ADDENDUM #02

Project Name:
Iowa DAS - DOC 4JD CBC New Central Office Building
DAS# 9488.00
RFB 948800-01
Addendum #02
Dated: May 07, 2026

ADDENDUM NUMBER TWO
To Contract Documents for:
IOWA DAS – DOC 4JD CBC NEW CENTRAL OFFICE BUILDING
SVPA Project No. 25079
Owner Project No. 9488.00

- (7) Pages REVISED Section 08 4113
- (7) REVISED Architectural Drawings A200, A300, A420, A421, A500, A511, A800

7 HEAD @ CORNER SF
SCALE: 1 1/2" = 1'-0"

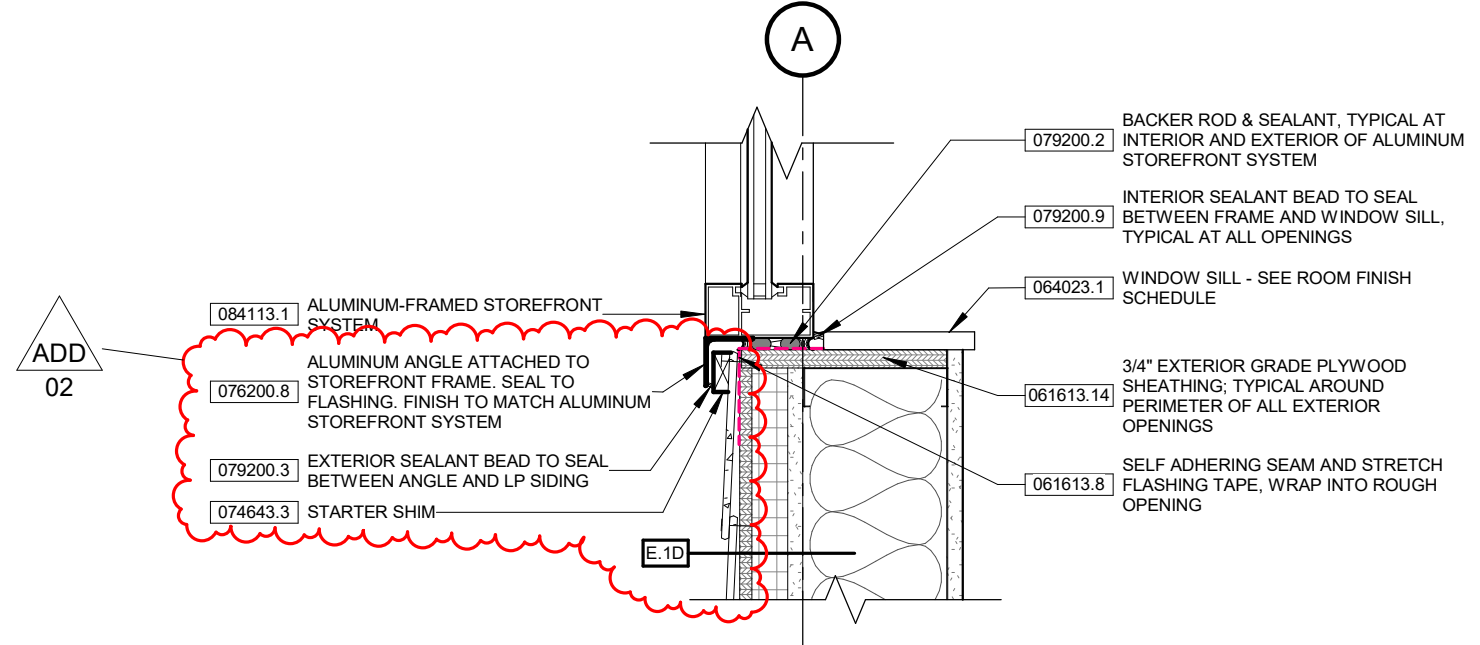
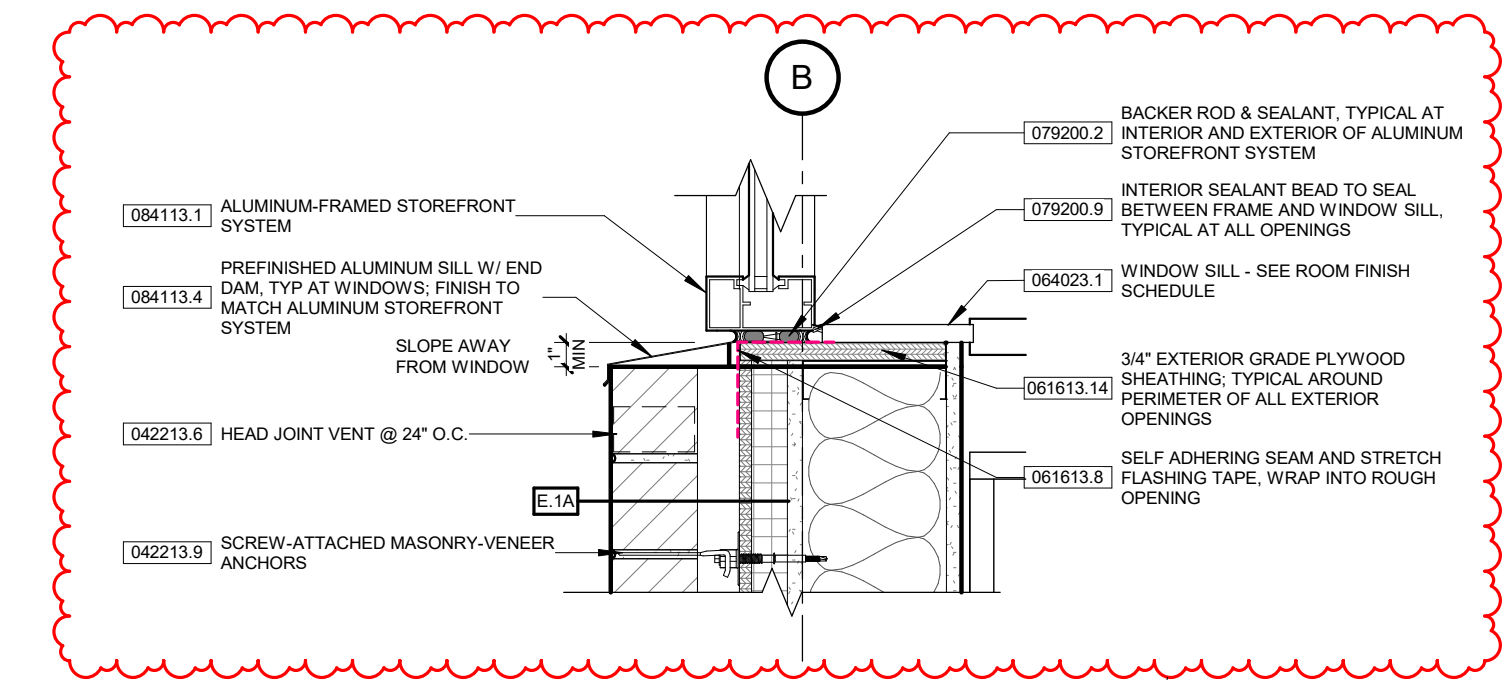
6. Sheet A511 – SECTION DETAILS

- A. ADD detail 8 to sheet.
- B. REVISE keynotes and detail elements for details 6 and 7.
- C. See attached revised sheet A511.

2 LEVEL 2 - FLOOR FINISH PLAN
SCALE: 1/8" = 1'-0"

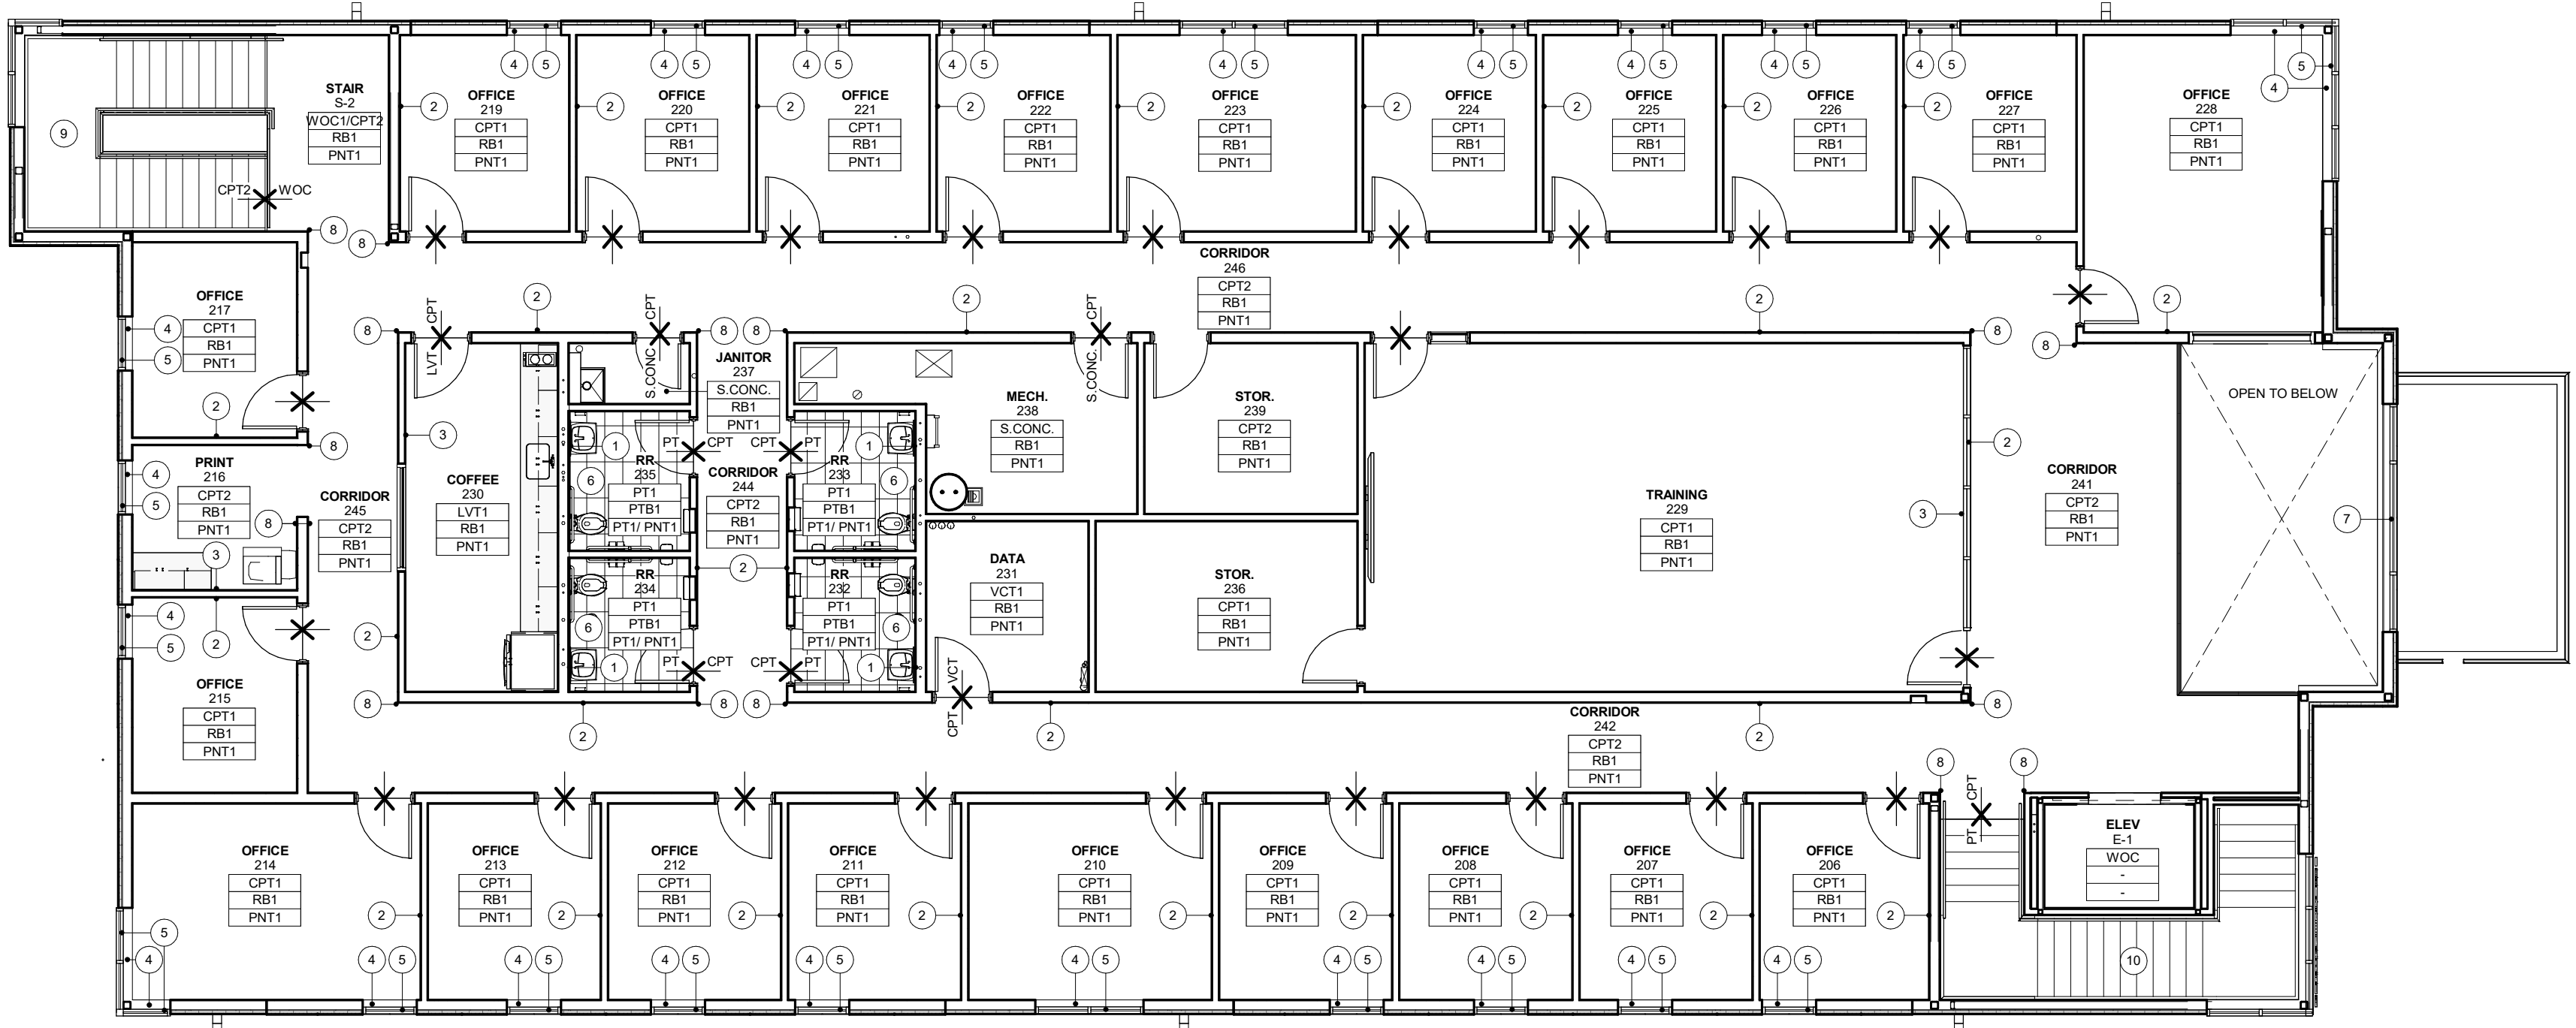
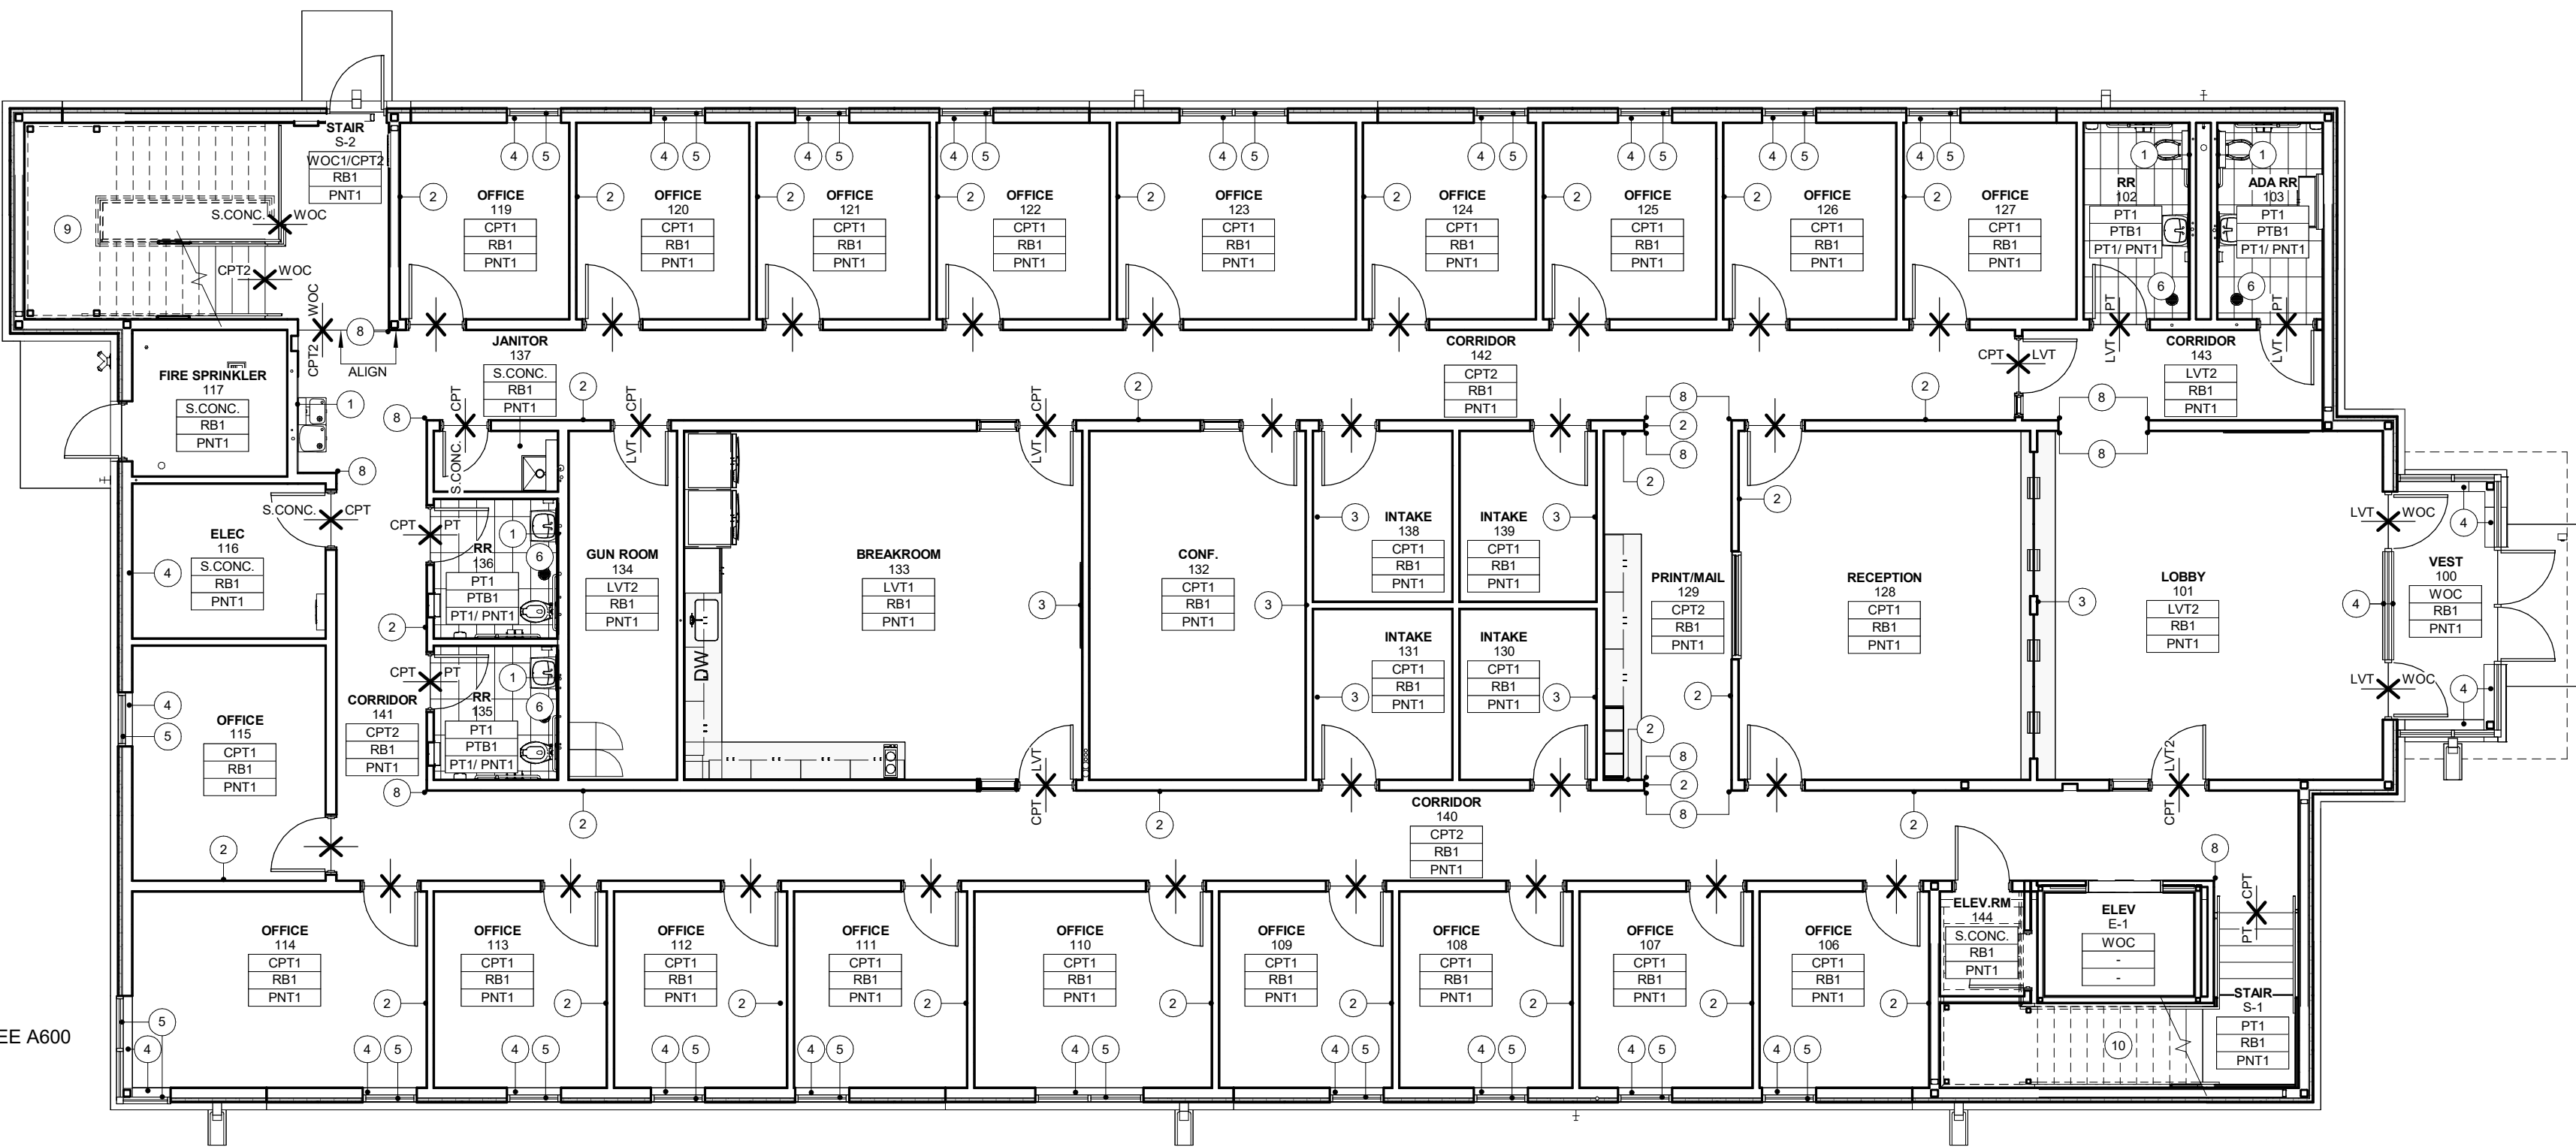
7. Sheet A800 – FLOOR FINISH PLAN

- A. REVISE materials PLAM1, PLAM2, SS1, and PNT3.
- A. See attached revised sheet A800.
